SMF comments

Pete Anslow, Ciena

IEEE P802.3bs Task Force, SMF Ad Hoc, 1 March 2016

Reflection budget proposals 400GBASE-LR8

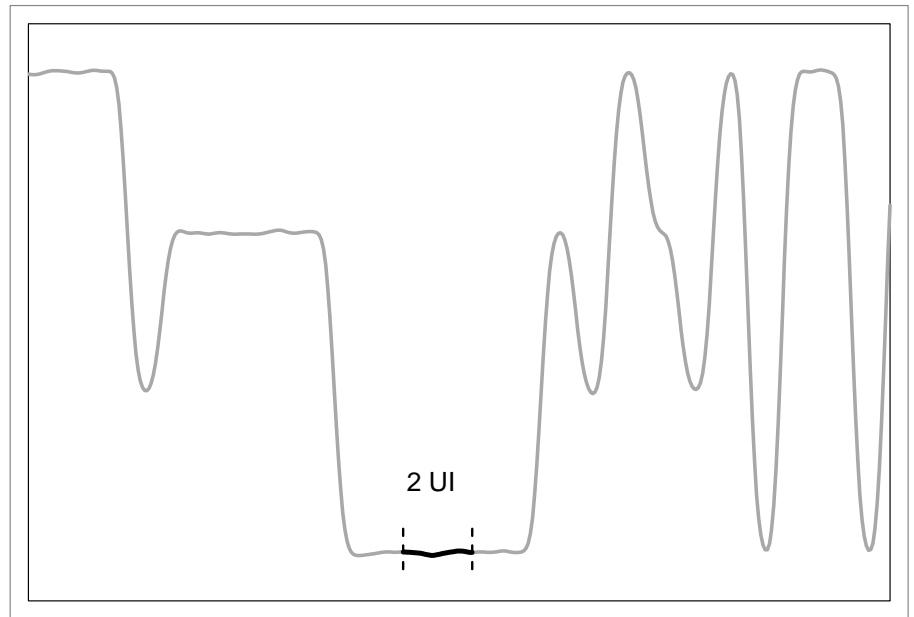
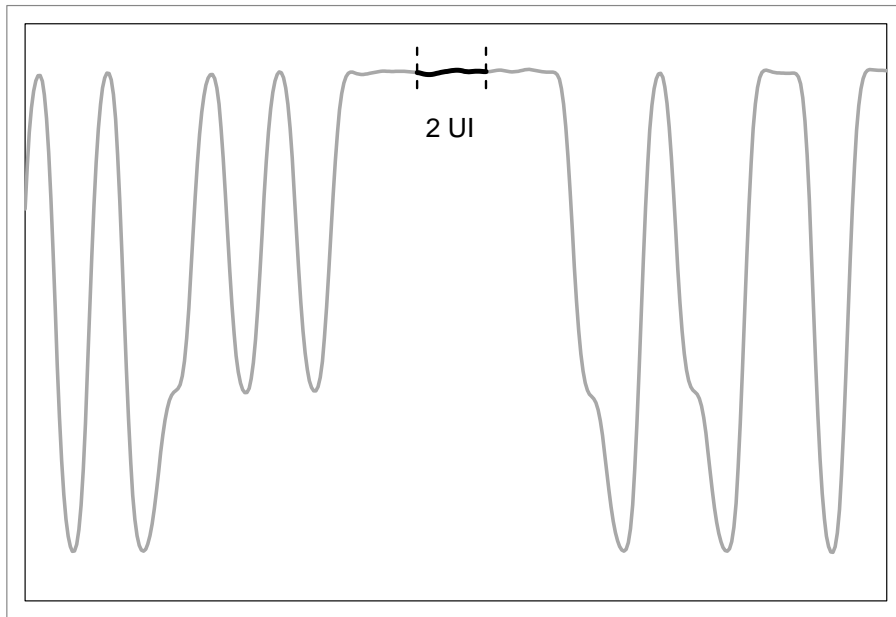
Parameter	D1.1	Liu	Anslow	Proposal	Unit
Table 123-7					
Average launch power, each lane (min)	-2.5	-2.2	-2.2	-2.3	dBm
Outer Optical Modulation Amplitude (OMA _{outer}), each lane (min)	0.5	0.8	0.8	0.7	dBm
Launch power in OMA _{outer} minus TDP, each lane (min)	-0.5	-0.2	-0.2	-0.3	dBm
Optical return loss tolerance (max)	TBD		15.5	17.6	dB
Transmitter reflectance (max)	TBD	-26	-26	-26	dB
Table 123-8					
Average receive power, each lane (min)	-8.8	-8.5	-8.5	-8.6	dBm
Receiver reflectance (max)	TBD	-26	-26	-26	dB
Receiver sensitivity (OMA _{inner}), each lane (max)	-11.6	-11.8	-11.8	-11.9	dBm
Table 123-9					
Power budget (for maximum TDP)	8.7	9.2	9.2	9.2	dB
Maximum discrete reflectance	TBD	-35	-35	-35	dB
Allocation for penalties (for maximum TDP)	2.4	2.9	2.9	2.9	dB
Table 123-12					
100GBASE-FR8 Optical return loss	20		15.5	17.6	dB
Table 123-13					
[Channel] Optical return loss (min)	21		27	27	dB

123.11.2.2					
maximum discrete reflectance	26	-35	-35	-35	dB
Max number of -35 dB reflections		6	6	6
